Detailed Site Plan

DSP-19071

The Promise

STAFF REPORT

Parcel 1

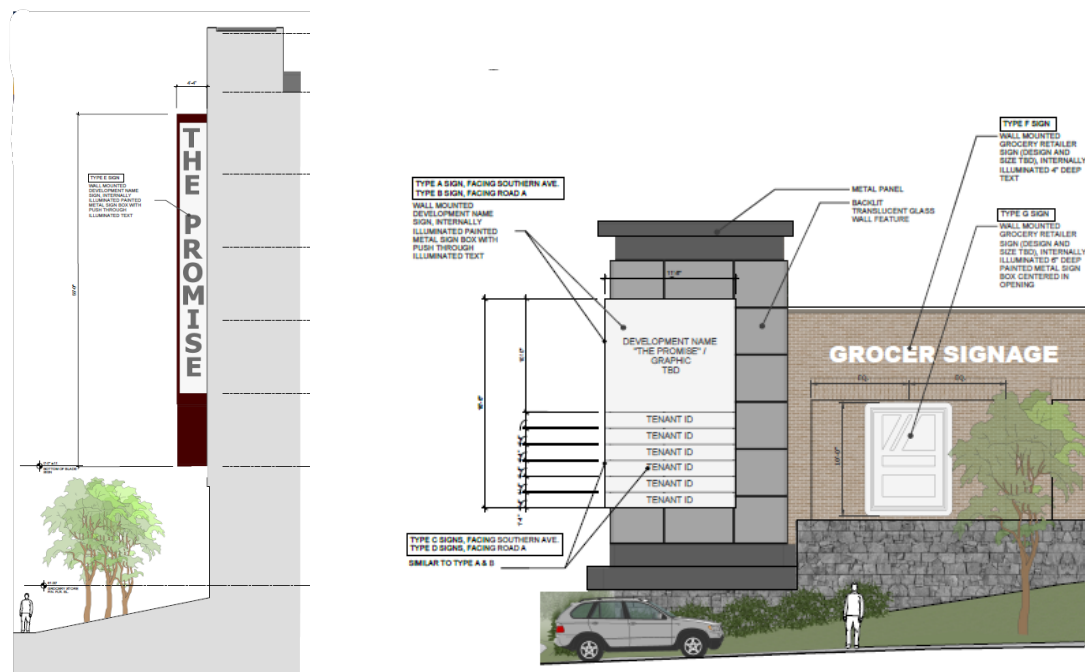
At the main entrance, the building located on Parcel 1 will have a blade sign with the community's name on the residential portion of the building, a building mounted sign displaying the community's name, the grocery tenant, and the other property tenants, and two additional grocery identification signs. The blade sign will be two-sided, 55 feet tall, vertically mounted, and extending approximately 4 feet from the face of the western building façade on Southern Avenue. This two-sided sign will be an internally illuminated, painted metal cabinet with push-through illuminated text.

The building mounted signage will be located on the front façade facing Southern Avenue, and at each of the customer entrances to the grocery store. A wall mounted, grocery store sign will face Southern Avenue, directly mounted to the brick façade, and be internally illuminated. The building mounted sign, displaying the community graphic and the tenant names, will be placed on the west side facing Southern Avenue, and wrapping the northwest corner to display the same information facing north. These signs will be affixed to a backlit
